Work Order ID 129115

Item Name: Baggage Compartment Protector Floor

DART SERVICE INSTRUCTION

TO AMEND INSTALLATION INSTRUCTIONS IIN-D407-781-2 REV. A OR LATER APPROVED REVISION
AND INSTRUCTIONS FOR CONTINUED AIRWORTHINESS ICA-D407-781 REV. 3 OR LATER REVISION

**FIGURE 1 - D3879-1 BAGGAGE COMPARTMENT WALL
PROTECTOR - ALTERNATE INSTALLATION**

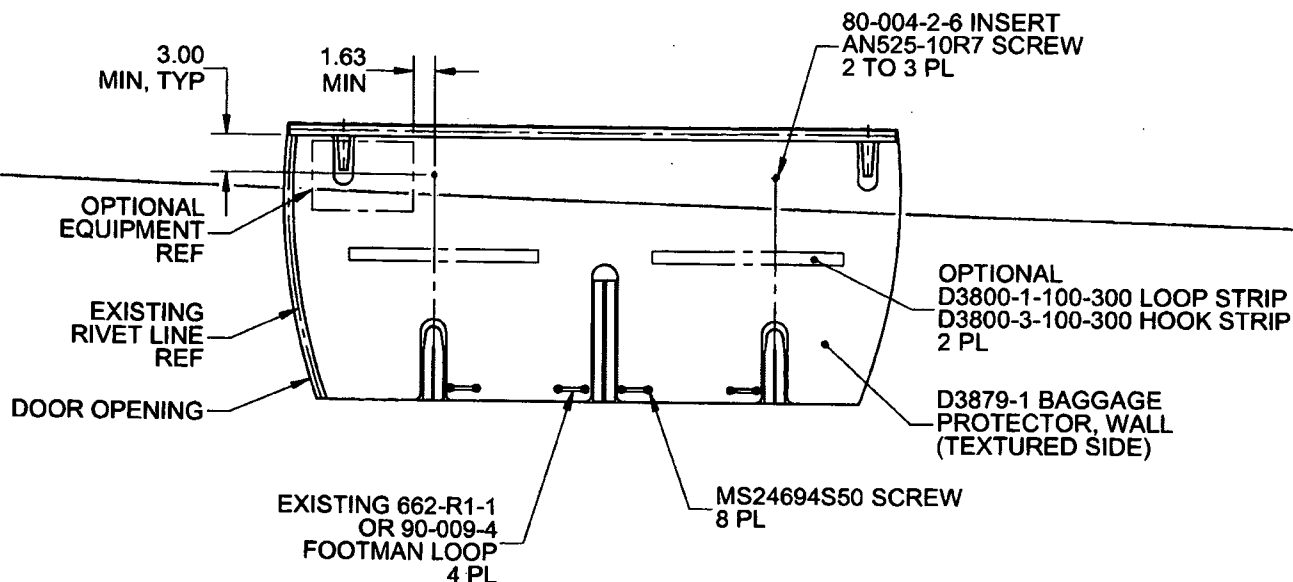
In some aircraft, the top portion of the D206-781-041 Baggage Compartment Wall Protector Kit cannot be installed as indicated in IIN-D407-781-2. The purpose of this DSI is to provide an alternate mounting method to fasten the top portion of the D206-781-041 Baggage Compartment Wall Protector Kit.

It is acceptable to replace qty(2) D3930-1 Clips with qty(2) 80-004-2-6 Inserts. Locate and mark location of the two attachment holes on the baggage compartment wall as shown in Figure 1 of this service instruction. Install 80-004-2-6 Inserts at the marked locations in accordance with Section 3-2-12 of BHT-206-SRM-1. It is acceptable to trim the wall protectors to accommodate optional equipment or transfer attachment holes to the wall protector and install the optional equipment on top of the wall protector with longer fasteners.

Amend the D206-781-041 Baggage Compartment Wall Protector Kit parts list as follows:

Qty -061	Qty -031	Qty -041	Part Number	Description
X			D206-781-061	BAGGAGE COMPARTMENT PROTECTOR KIT (FLOOR AND WALL)
1	X		D206-781-031	BAGGAGE COMPARTMENT FLOOR PROTECTOR KIT
1		X	D206-781-041	BAGGAGE COMPARTMENT WALL PROTECTOR KIT
		2	AN525-10R7	SCREW
		2	80-004-2-6	INSERT
